Subject: Addendum to Geotechnical Investigation Report
Response to Geotechnical Review Sheet
Proposed Oakmont of Agoura Hills Senior Facility
29353 Canwood Street
Agoura Hills, California

CITY OF AGOURA HILLS - GEOTECHNICAL REVIEW SHEET

Planning Case #: CUP-001231-2016, SIGN-01232-2016, OAK-01233-2016

Subject: Addendum to Geotechnical Investigation Report
Response to Geotechnical Review Sheet Dated July 11, 2016
Proposed Oakmont of Agoura Hills Senior Facility
29353 Canwood Street
Agoura Hills, California

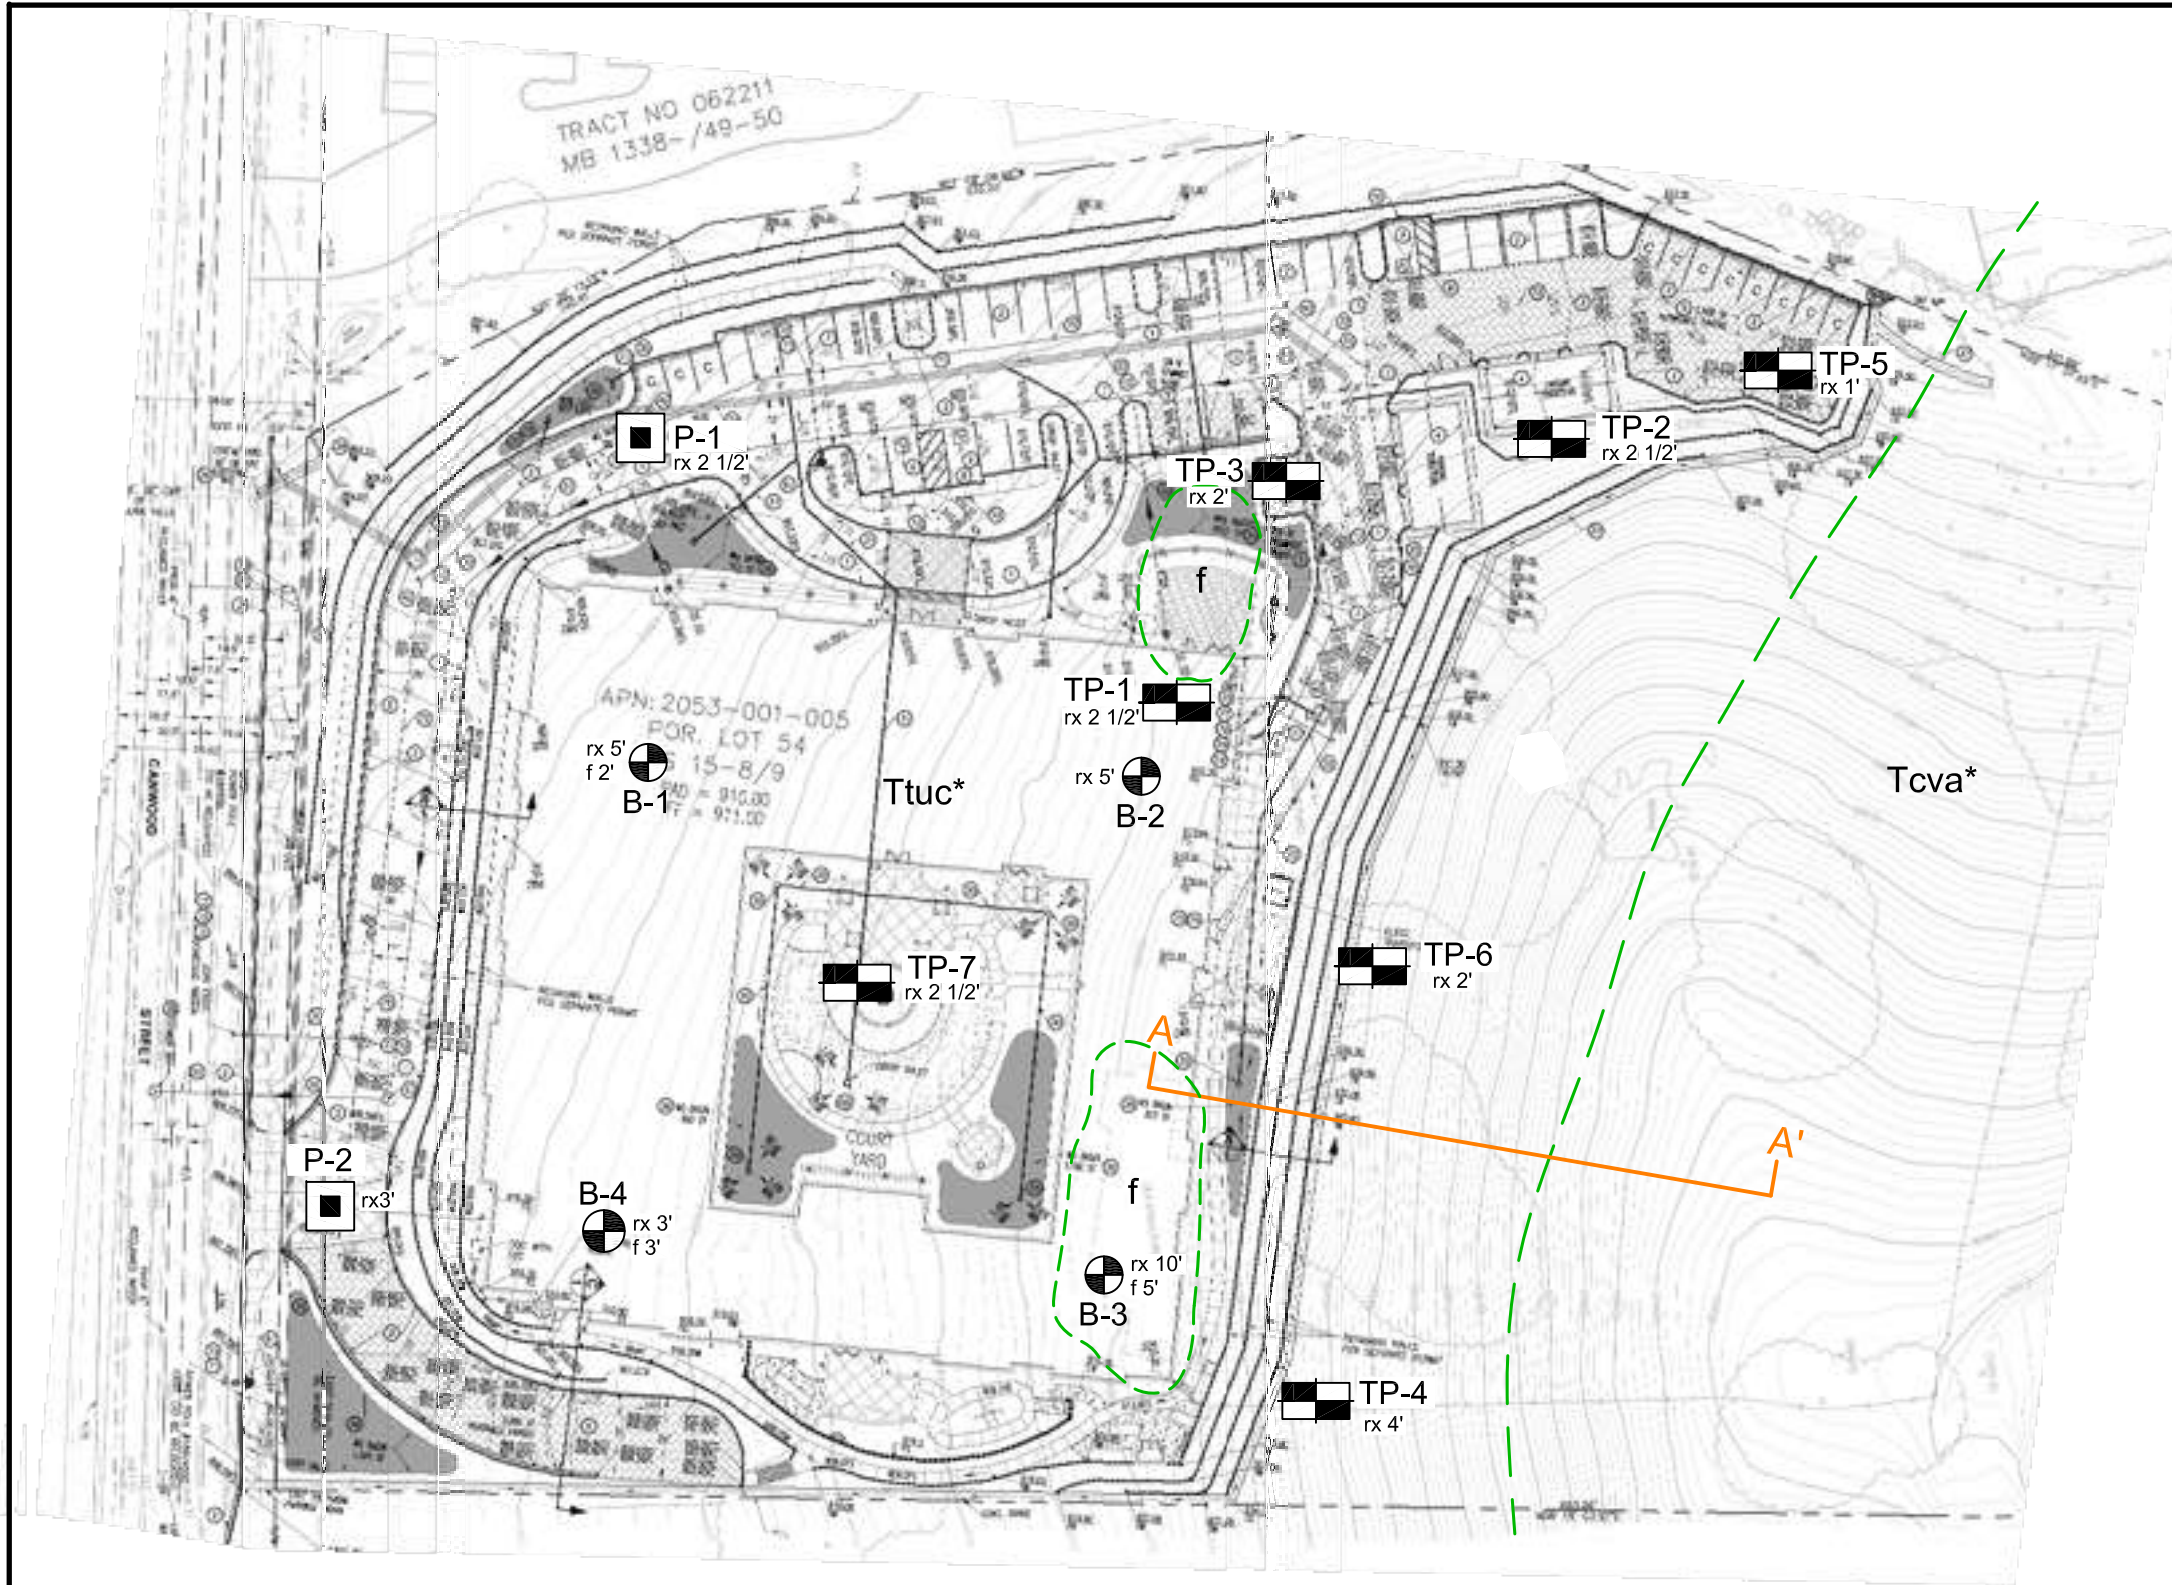
- 1. The consultant should provide an updated geologic map based on a legible copy of the latest development plan. The map should include all geologic data including contacts between all geologic units (including alluvial units if appropriate), structural information and a complete geologic legend. The consultant should discuss the basis for the location of the contact between Tcva and Ttuc (sic) indicated on the map.*

1. The consultant should review development plans as they become available to verify compliance with recommendations in the above-referenced reports. A geotechnical map using the proposed grading plan as a base map should be included. Cross sections should be updated as necessary

An updated geological and geotechnical map on the basis of the proposed grading plan, prepared by Huitt-Zollars, Inc., dated (last saved) April 16, 2016, is attached hereto.

An updated geological and geotechnical map on the basis of the proposed grading plan, prepared by Huitt-Zollars, Inc., dated (last saved) April 16, 2016, is attached hereto.

GEOLOGIC CROSS SECTION A-A'		
FOR: OAKMONT SENIOR LIVING	GEOTECHNICAL INVESTIGATION OAKMONT OF AGOURA HILLS SENIOR FACILITY APN 2053-001-005	ENCLOSURE "A-2.2"
DATE: JUNE 2016	29353 CANWOOD STREET AGOURA HILLS, CALIFORNIA	JOB NUMBER 15473-3A

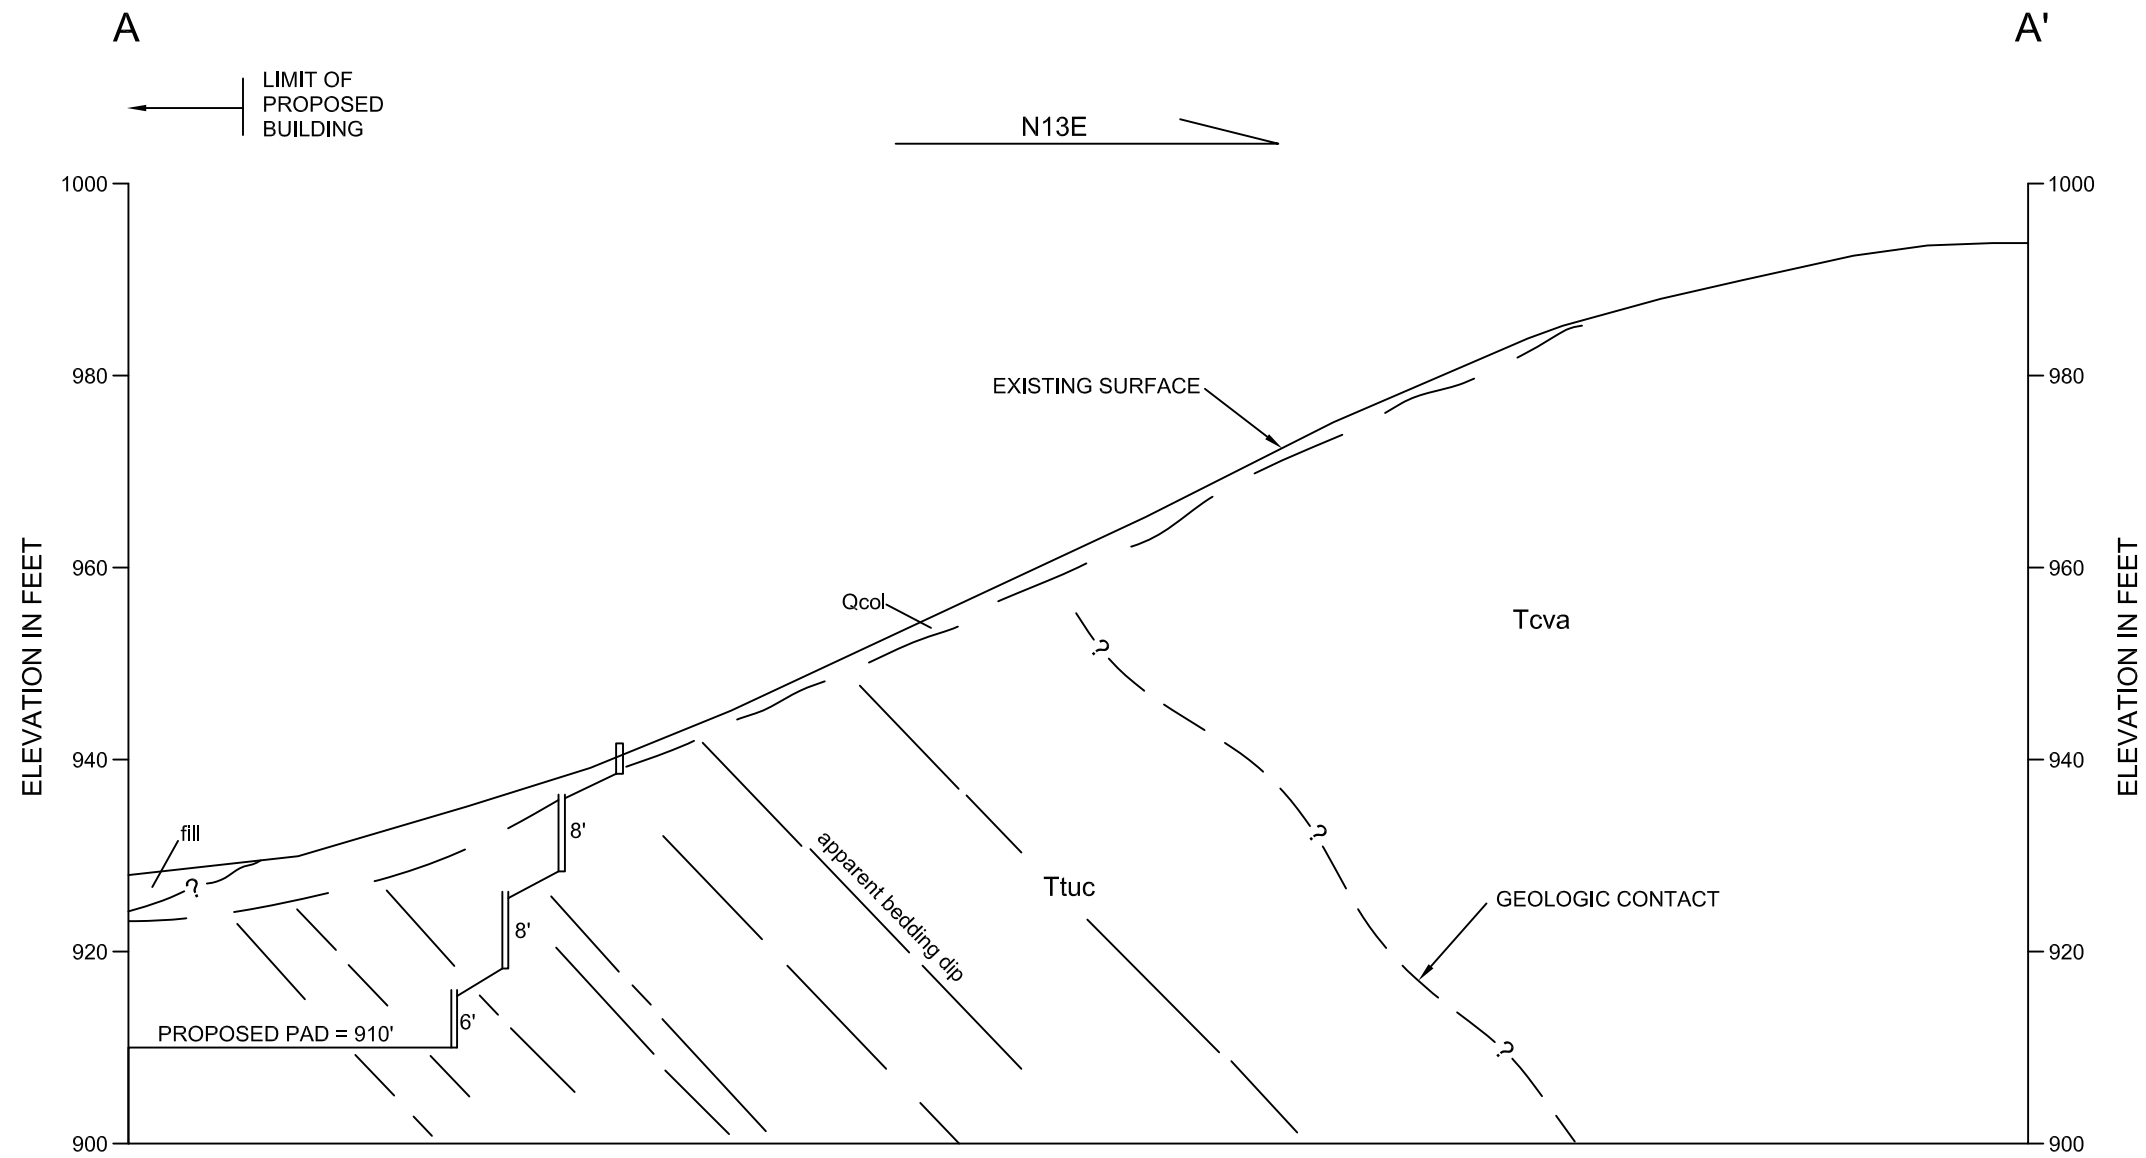
1. The consultant should review development plans as they become available to verify compliance with recommendations in the above-referenced reports. A geotechnical map using the proposed grading plan as base map should be included. Cross-sections should be updated as necessary to reflect changes in the proposed grading relative to the current grading concept. Additional geotechnical recommendations should be provided as necessary.

BUILDING SETBACK DETAIL		
FOR: OAKMONT SENIOR LIVING	GEO TECHNICAL INVESTIGATION OAKMONT OF AGOURA HILLS SENIOR FACILITY APN 2053-001-005 29353 CANWOOD STREET AGOURA HILLS, CALIFORNIA	ENCLOSURE "B-1"
DATE: JUNE 2016		JOB NUMBER 15473-3A
		CHJ Consultants

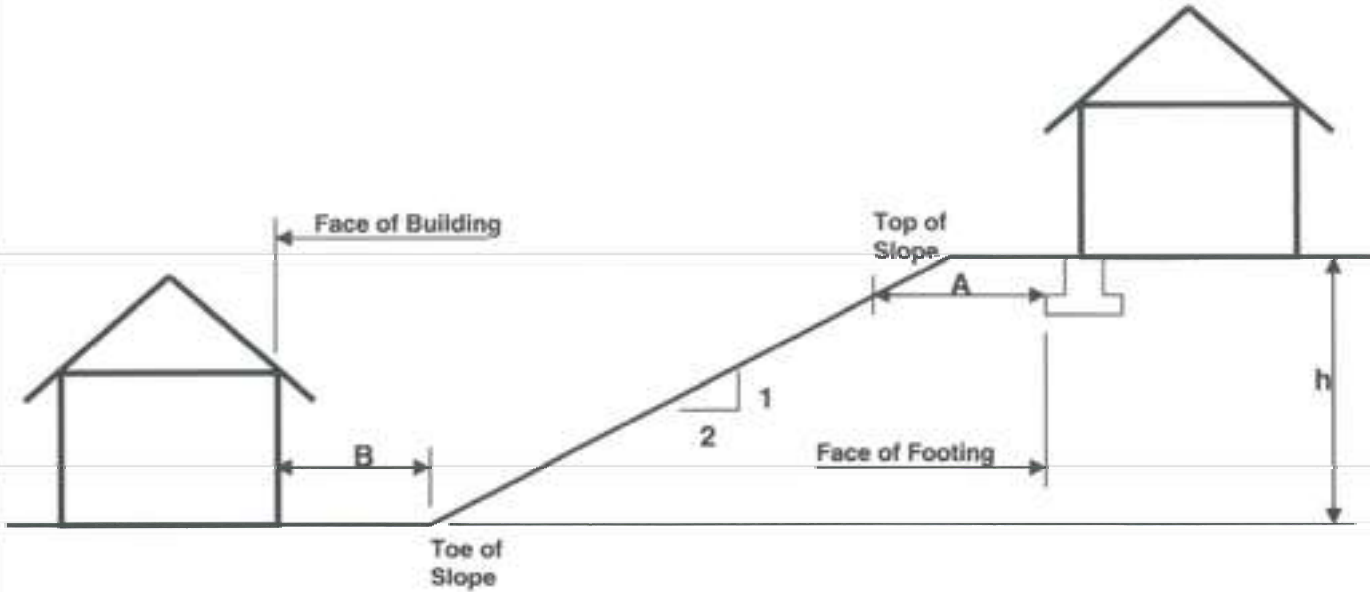
- 4. The consultant should provide recommendations for the foundation to slope setback in accordance with the City of Agoura Hills building ordinance.*
